Planning Board Report
Major Site Plan and Shoreland Zoning Permit for Royal River Park Improvements
Yarmouth Community Services, Applicant
Map 42 Lot 51; Medium Density Residential (MDR), Shoreland Overlay District (SOD), and Resource Protection (RP) Zoning District
Prepared by Erin Zwirko, Director of Planning and Development
Report Date: February 20, 2025; Planning Board Date: February 26, 2025

TO: Erin Zwirko, AICP, Director of Planning
FROM: Steven Johnson, P.E., Town Engineer
DATE: February 12, 2025
RE: Major Site Plan Application Review: Royal River Park

Proposed Site Plan

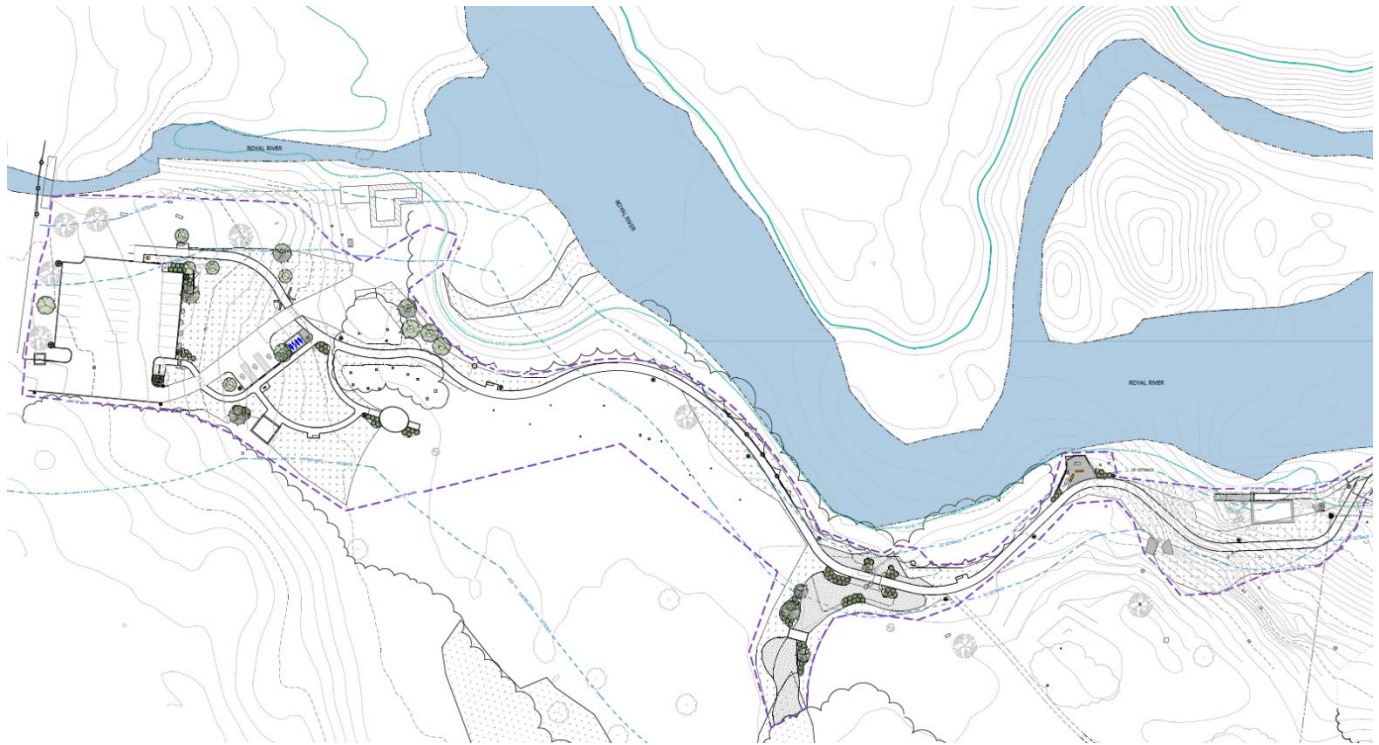
Staff Comments: It appears that the proposed project is in compliance with this standard. The improvements include widening the entrance to the East Elm Street parking lot to decrease congestion of vehicles maneuvering to enter or exit the parking lot at the same time.

The existing parking lot has 25 parking spaces, of which 3 spaces are ADA parking spaces. The proposed improvements will decrease the number of parking spaces in the lot to 21 spaces with 1 ADA parking space. The decrease in parking within the lot is to ensure that there is adequate aisle space to safely maneuver vehicles within the lot. Three additional ADA parking spaces will be located closer to the performance and picnic space within the park. Parks maintenance vehicles will continue to have parking at the maintenance building.

In addition, close to the performance and picnic area, four bike racks will be installed. The type of bike rack is a hoop-style bike rack, which is not the lollipop style rack used along Main Street. The final detail for bike racks shall be specified by the Yarmouth Community Services Director.

Staff Comments: The proposed improvements will include pedestrian-scale lighting along the pathway to support walking and biking activities from late fall to early spring. New lighting is also proposed around the parking lot.

YCS acknowledges that previous comments were provided regarding light pollution, and as a result the light fixtures chosen will direct light downward and are spaced to support the safety of users while minimizing any light pollution. Public comment regarding lighting has also been received and is attached. While a photometric plan has not been provided, Town staff support the Planning Board waiving this application item. However, as a condition of approval, an electrical layout plan shall be submitted showing how the fixtures will be served including conduit location and sizing.

Staff Comments: The application materials indicate that the proposed improvements, in part, will mitigate existing drainage and topography concerns around erosion of driveway shoulders due to stormwater runoff and an area of saturated lawn. Regarding the eroded driveway shoulders, which can be a hazard for park users, a shallow vegetated swale on the uphill side of the driveway will direct water away from the driveway and help prevent future erosion. Stormwater collected within this vegetated swale will be directed toward storm drains designed to safely convey the 25-year storm as required by the Town of Yarmouth ordinances. The saturated lawn area, which is difficult to maintain, will be converted to a green infrastructure element (i.e., a rain garden) that will be planted with native vegetation that offer visual interest and increased natural stormwater infiltration.
